TECHNICAL SERVICE BULLETIN

Date: 5/23/96

merit industries, inc.

- Problem:** Tournament Megatouch games' system date resetting to February 1995.
- Games affected:** A limited number of factory-made Megatouch Tournament games, and games that were field-upgraded to Tournament Megatouch, that use SC3981 at U51.
- Symptoms:** System date resetting to February 1995.
- Cause:** PAL programming may cause NV RAM error.
- Solution:** Replace U51 PAL SC3981 with SC3981-0A.

FIGURE 1 - CRT-260 CPU BOARD

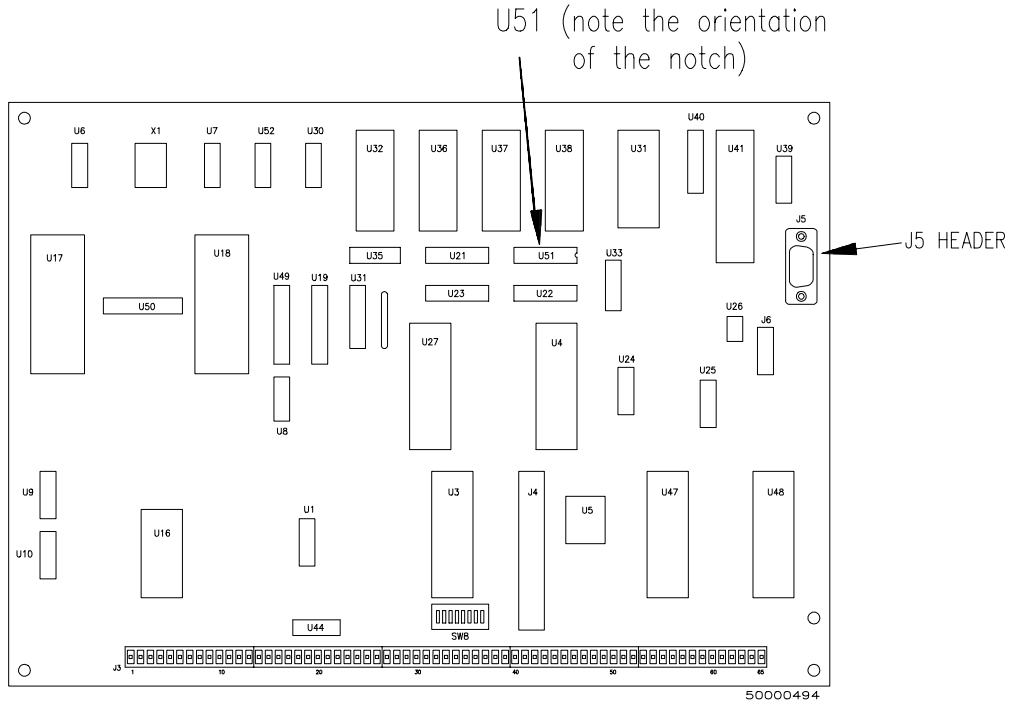
1. Turn off and unplug your game.
2. Open the CPU section door to access the CRT-260 board.
3. Using Figures 1 and 2, locate U51 on the CRT-260.
4. If your game comes equipped with the CRT-266/TTL touchscreen controller assembly, you will need to remove it to access U51 (U51 is located beneath this assembly).
5. Using a small screwdriver, gently pry the existing PAL from its socket.
6. Install the new PAL, SC3981-0A, at U51.
7. Reinstall the CRT-266/TTL assembly if you removed it.
